SERVICE LETTER

No. 682B

Piper Aircraft Corporation

Required Inspection of Part No. 69650 Piston Pin -- reference attached Lycoming Service Bulletin No. 367D, dated March 8, 1974.

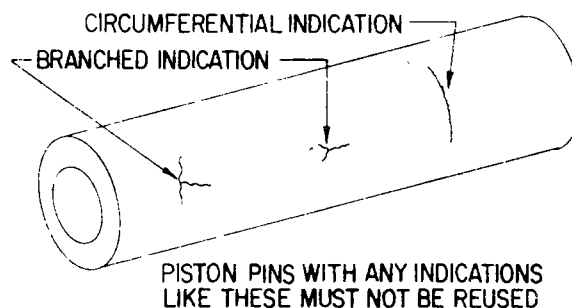
Owners and operators having access to magnetic inspection facilities may inspect their piston pins locally rather than return them to Avco Lycoming. The accompanying figure shows the type of indications that may be encountered and the following procedure describes the method of inspection to be used.

6. Use a 5-power magnifying glass to examine the piston pins. Pay particular attention for indications around the circumference of the pin; branched indications as shown in the figure are conclusive evidence of unsatisfactory pins.

7. Piston pins that are found to be free of indications should be demagnetized, cleaned and reused. A wire, confirming the inspection should be sent immediately to Avco Lycoming, collect. Include the date of inspection and serial number of the engine.

If any piston pins are found to have magnetic indications, the quantity of such pins and serial number of the engine from which they were removed should be promptly sent to Avco Lycoming by wire, or cable, collect, and ship the properly identified pins, via air shipment collect to Avco Lycoming and mark the package for the attention of the Service Department.
